A d d e n d u m

Iowa Department of Transportation
Office of Contracts

B.O.	Proposal ID	Proposal Work Type	County	Project Number	Addendum
008	32-0046-028-A	RCB CULVERT REPLACEMENT - TWIN BOX	EMMET	BRFN-004-6(28)--39-32 BRFN-004-6(29)--39-32	17MAR008.A01

Minutes for Emmet County, BRFN-004-6(28,29)--39-32 Pre-Bid Meeting, 2- RCB Culvert Replacements – Twin Box Under Iowa 4 and the adjacent UP Railroad

RCP STORM SEWER TIE-IN (NON-STANDARD)

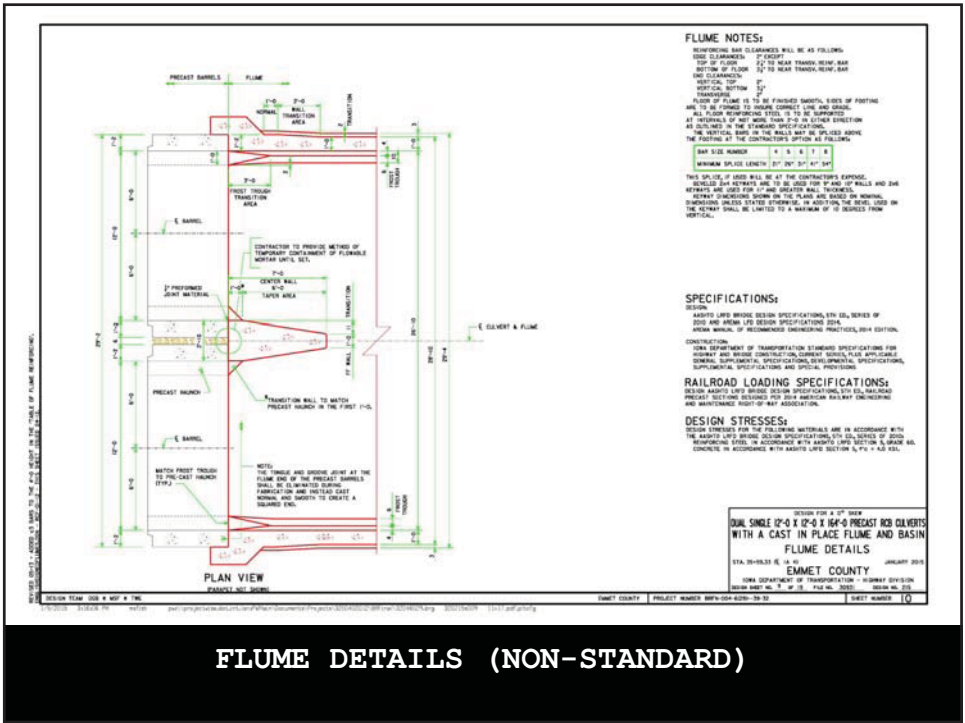
1. Provide the following note in the bid item reference for the "Flowable Mortar" bid item on Sheet 2 (28) and Sheet 2 (29):
Alternate concrete mixes may substituted for the "Flowable Mortar" as approved by the Engineer at no additional cost to the state.
2. Per AREMA 2.3.2 and 16.6.1, dry casting is allowed for precast culverts.
3. Sheet 6 (29) and Sheet 10 (28):
Only the top 1 ft of the granular blanket is required to meet the 3/8 in aggregate requirement.
Granular material size for the bottom 1 ft of the granular blanket would be based on the conditions that are encountered during excavation. Material would need to be certified and would be paid for as Granular Material.
4. Sheet 9 (29) and Sheet 12 (28):

The 24" RCP section may be cast into the precast barrel using a secondary pour, so modifications to the precasters forms are not required. The RCP pipe shall be cast in the precasters plant before shipment of the precast sections to the construction site.

- 14) Who is doing the inspection? Iowa DOT is doing all inspection.
- 15) What class is the 24" RCP and can it be grouted in afterwards rather than cast in place as shown on plan sheets 9 and 12 of both plans? Refer to addendum note 4 and 5 above.

5. The 24" RCP pipe shall meet the Iowa DOT requirements for pipe class as shown in the plans. Plans were review and approved by the UPRR.
